PWS ID#: 41508192

Washington Island Art & Nature Ctr
Town Of Washington
PO BOX 220
Washington Island, WI 54246

Subject: Sanitary Survey Report

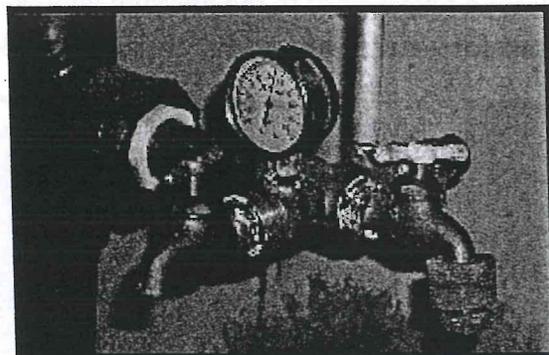
1. Maintain the pressure tank and pump installation in a manner to provide a smooth end, metal, downturned, dedicated, raw sampling faucet that is at least 12 inches above the surrounding grade. If a lower drain faucet is needed for the pressure tank a second faucet that is threaded with a vacuum breaker may be installed. I enclosed a diagram of faucets for your reference.

1. **Rearrange the piping by the pressure tank for dedicated raw water smooth end sampling faucet. The faucet shall be a minimum of 12 inches above the surrounding grade. If a threaded faucet is desirable for connecting a hose to drain the tank a second faucet may installed on a tee. Threaded faucets shall have a vacuum breaker to protect the potable water system from backflow. (Installing the pressure tank on a concrete block to elevate it will allow the piping to be located at the bottom of the tank to provide good drainage and a sampling tap at least 12 inches above the floor of the well house).**

It is recommended that you install a dedicated sampling faucet if your system does not have a good sampling site. If both a smooth end sampling tap and threaded faucet with a vacuum breaker are needed for hose connections a tee with both style faucets may be installed.
